## ORIGINATION FORM

Proposed Revisions to a Standard Plans Index  
(Please provide all information — Incomplete forms will be returned)

Index Number: 450-199  
Sheet Number (s): Sheet 1  
Index Title: PRESTRESSED I-BEAMS BUILD-UP & DEF  
DATA

**BEAM CAMBER AND BUILD-UP NOTES:**

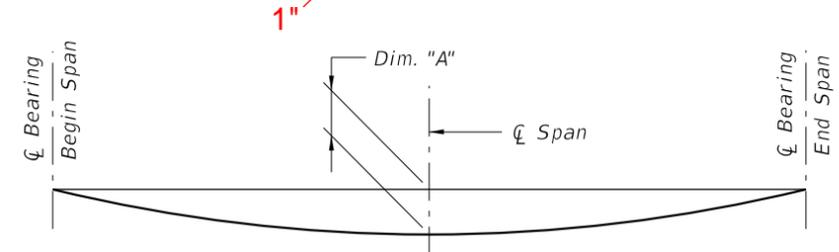
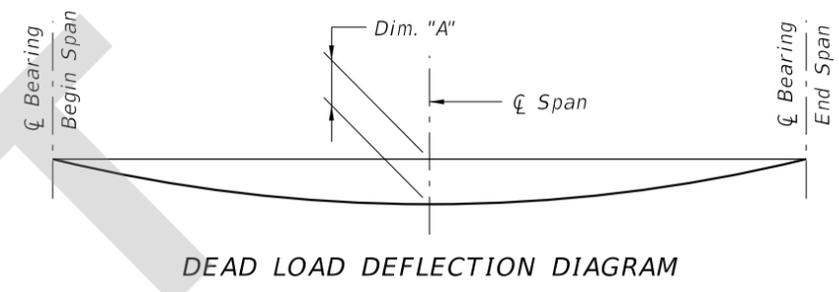
Change the camber tolerance to 1" from 1/2".

The build-up values given in the Data Table\* are based on theoretical beam cambers. The Contractor shall monitor beam cambers for the purpose of predicting camber values at the time of the deck pour. If the predicted cambers based on field measurements differ more than  $\pm 1/2$ " from the theoretical "Net Beam Camber @ 120 Days" shown in the Data Table\*, obtain approval from the Engineer to modify the build-up dimensions as required. When the measured beam cambers create a conflict with the bottom mat of deck steel, notify the Engineer a minimum of 21 days prior to casting.

The build-up values given in the Data Table\* are based on theoretical beam cambers. The Contractor shall monitor beam cambers for the purpose of predicting camber values at the time of the deck pour. If the predicted cambers based on field measurements differ more than +/- 1" from the theoretical "Net Beam Camber @ 120 Days" shown in the Data Table\*, obtain approval from the Engineer to modify the build-up dimensions as required. When the measured beam cambers create a conflict with the bottom mat of deck steel, notify the Engineer a minimum of 21 days prior to casting.
